STAFF REPORT: OCTOBER 14, 2020 MEETING

APPLICATION NUMBER: 20-6878

ADDRESS: 2415 SEMINOLE

**SCOPE OF WORK: DEMOLISH GARAGE (WORK COMPLETED / EXISTING VIOLATION);
ERECT NEW GARAGE / CARRIAGE HOUSE, NEW HARDSCAPING AND LANDSCAPING,**

Neighborhood examples and proposed plant

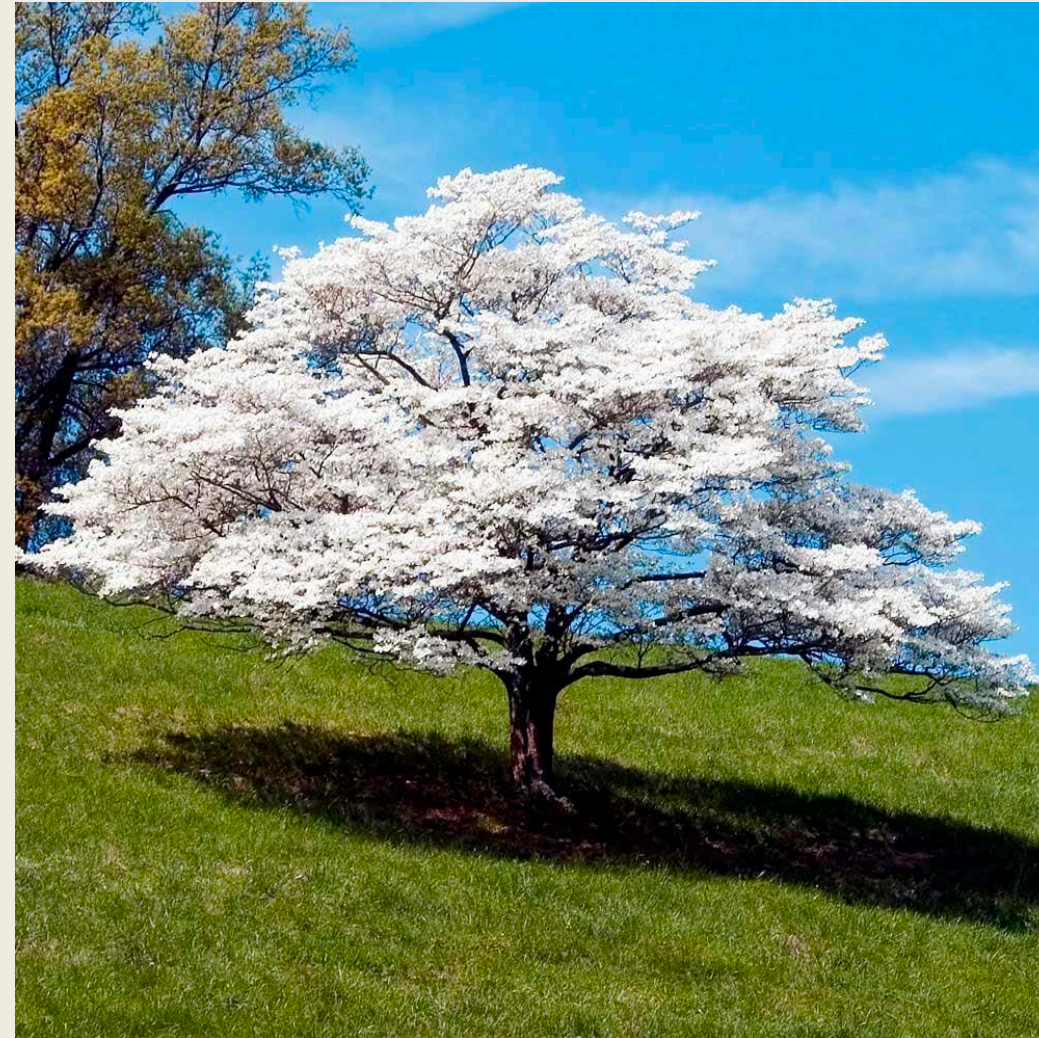
- **Remove existing shrubs** along north property line in the front yard and replace them with a **continuous hedge row of Holly Compact (Ilex crenata)**. The applicant proposed to maintain the height at 6-8' height.
- **Plant (1) one Baby Blue Spruce (evergreen) and (2) two White Dogwood ornamental trees** along south property line in the front yard.
- **Plant (1) American Red Maple shade tree** at the rear of the property

- ...At least (2) two additional shade trees (bringing total to three) are planted to re-establish a tree canopy along E. Vernor
 - ...that hedge row on the side property line is maintained at a max of 6' high to conform with HDC fence and hedge guidelines.

Proposed Backyard Tree

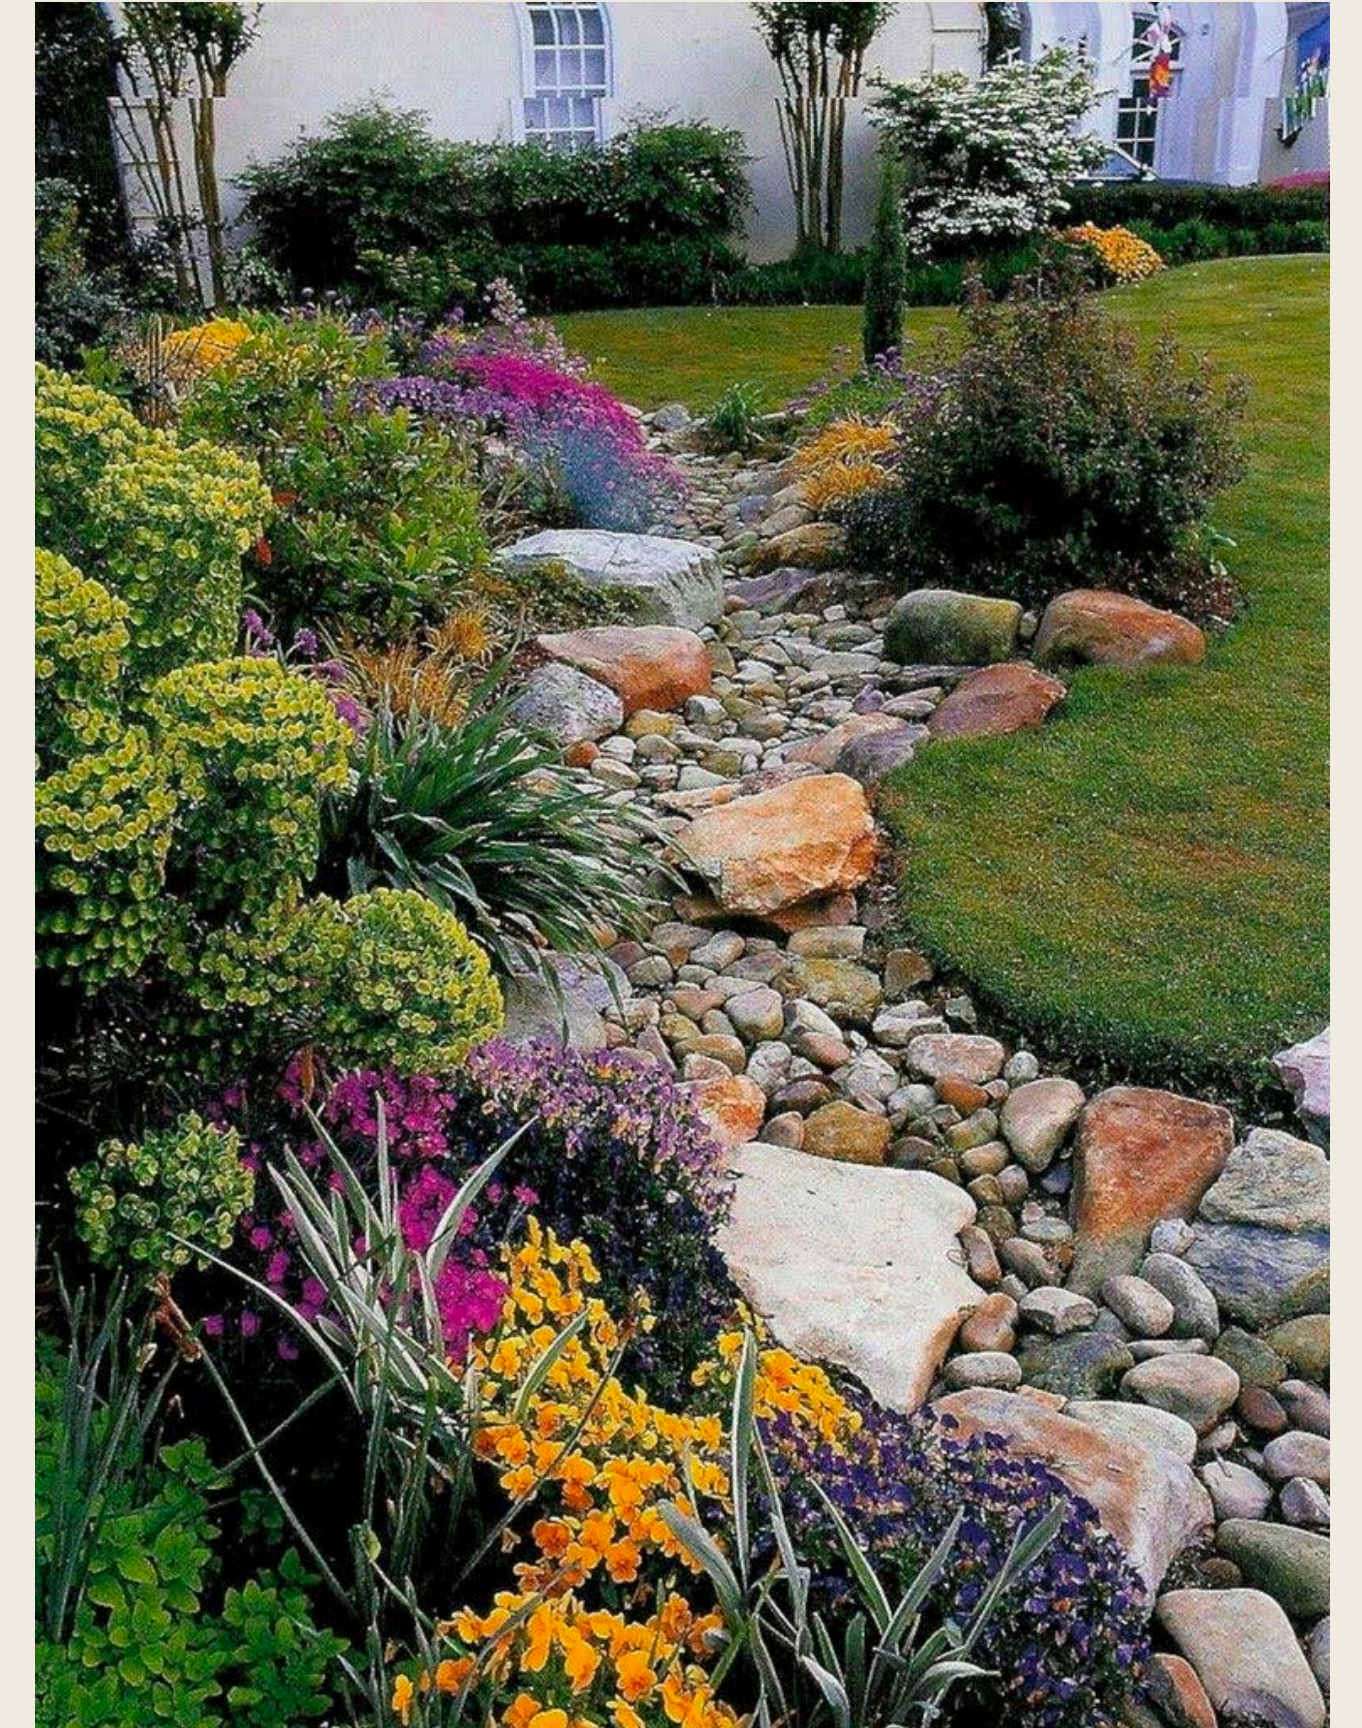
- **Landscaping:** The applicant has listed a desire to install new landscaping in various locations. One canopy tree is proposed. Given the importance of tree canopy in the district, and the loss of substantial tree canopy at this particular high-visibility area, more shade trees should be planted.
- **Create New Driveway:** Many homes on this block of Seminole have front entrance driveways, leading to parking in the rear. The driveway can be installed without removal of the mature trees on the Seminole right of way.

Proposed Garage

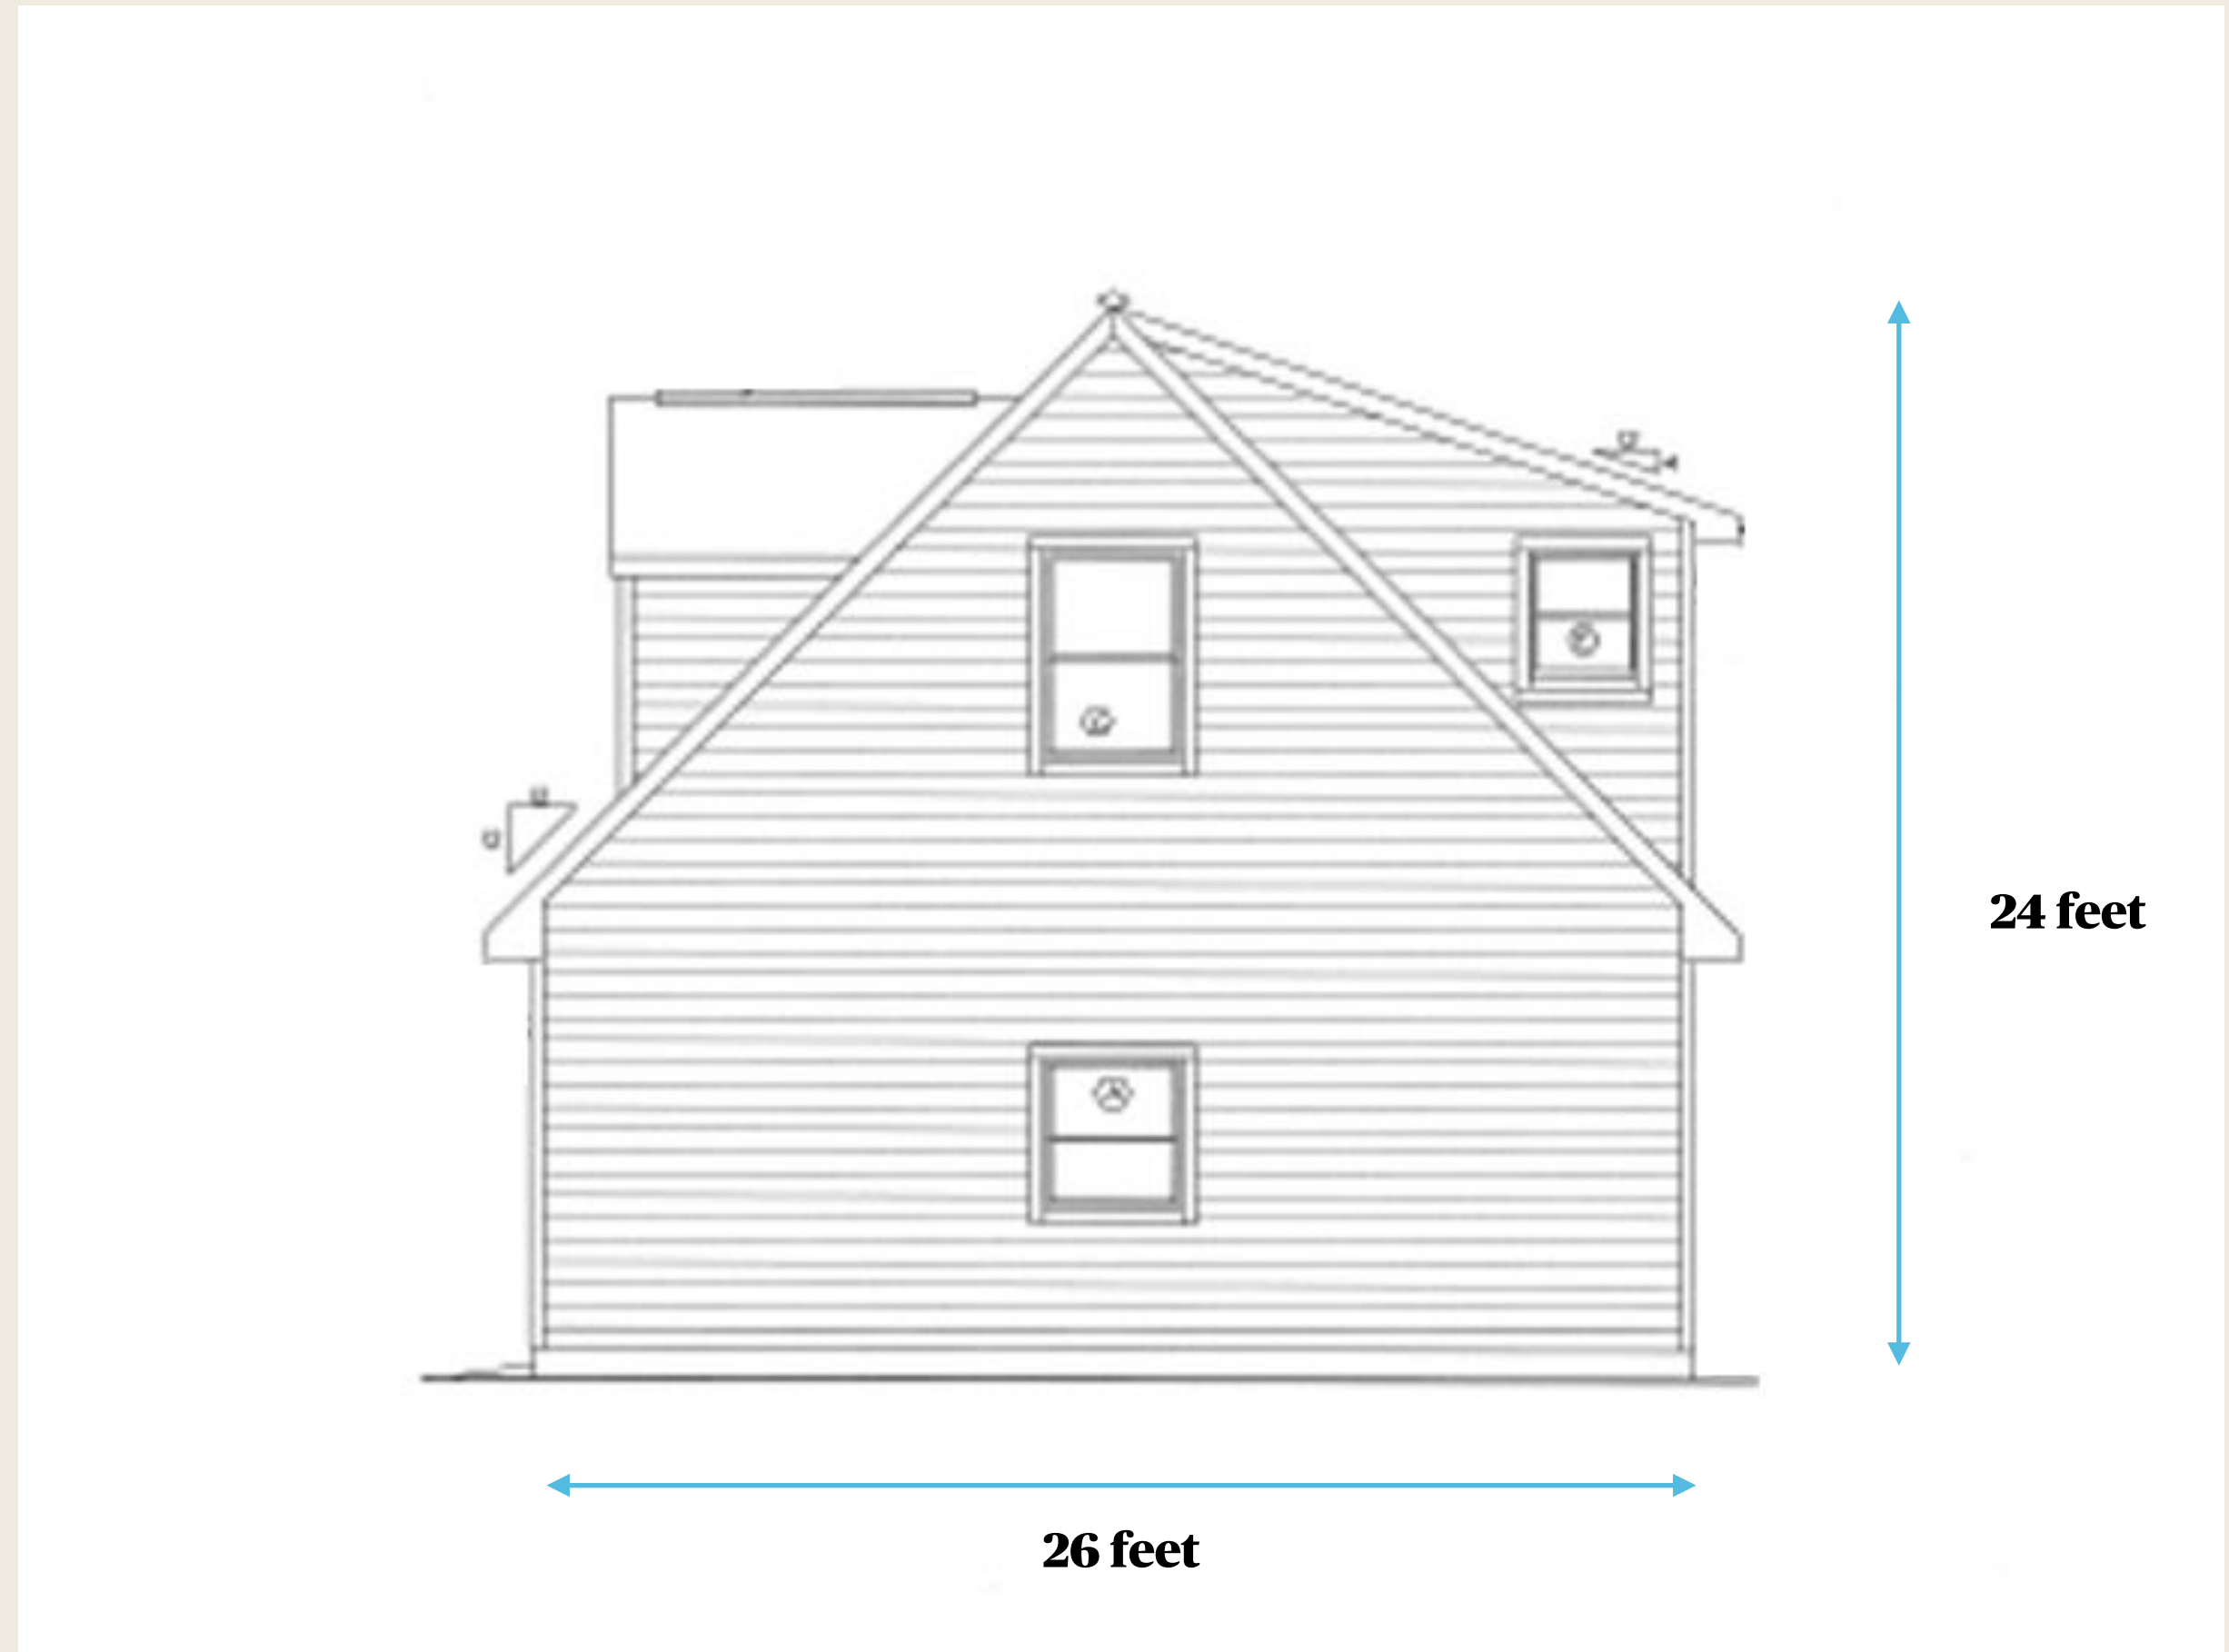
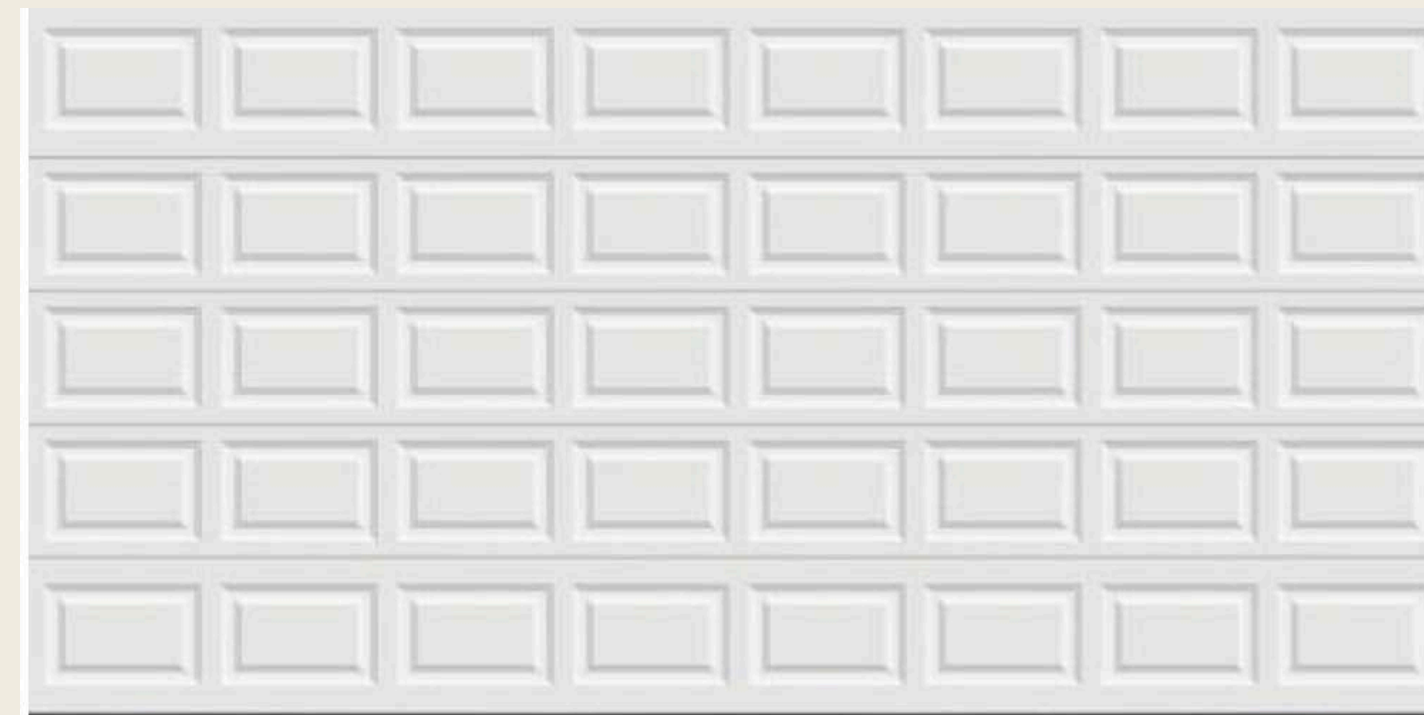
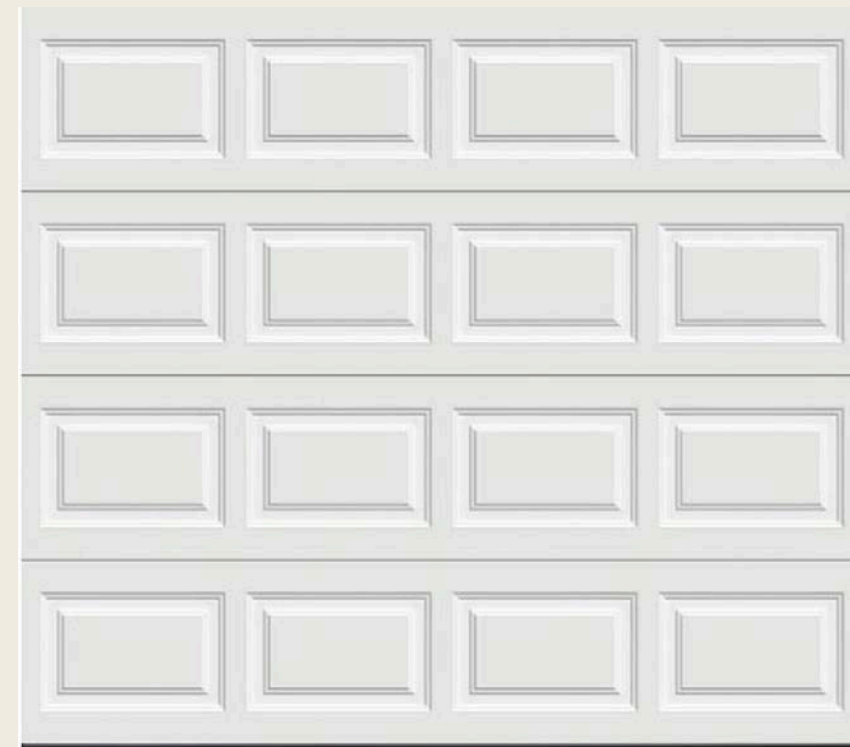
- **Three (3) lantern style exterior lights** will be mounted to the side of the garage between the doors.
 - **The east façade features (4) four windows, of various sizes and operations**, not specified in the scope of work.

- **The current east elevation drawing does show an overhead door, with a note that says this door will not be implemented.**
 - **North and South elevation drawings show (2) two double hung windows on the second floor, respectively and (1) one double hung window on the ground floor.**

The applicant is proposing to erect a Two-story, side-gabled, three-car garage on the Southwest corner of the property. Although the applicant has presented the proposed structure in the application as a garage, adding the habitable space on the second level appears to be a change of land use and would possibly qualify the new construction as a carriage house. The applicant will have to ensure that this is an approved use per the local zoning ordinances and clear all necessary permits with BSEED and BZA; approval from the HDC does not relieve the applicant from compliance with other applicable codes and requirements.

Staff finds nothing objectionable about the massing or styling of the proposed structure, or carriage houses in general, as there is plenty of precedent of their existence in Indian Village. The applicant is proposing to clad the structure in a manufactured Brazilian hard wood siding called **Cumaru siding**, painted white to match the home which would be appropriate for the local historic district. The applicant proposes to install fiberglass windows on the carriage house, and while staff recognizes that this new construction, they will still contend that this is not an appropriate material for the Indian Village Historic District. Staff would recommend wooden double hung windows for this project. Further, there are aspects of the proposal that are not currently represented on the elevation drawings that will need to be revised when seeking permits for construction including final count and location of windows and the removal of the garage door on the East façade, and the addition of gutters and downspouts for drainage.

- ... that applicant install wood windows instead of fiberglass and submit revised plans to accurately reflect final proposal prior to the issuance of a COA.
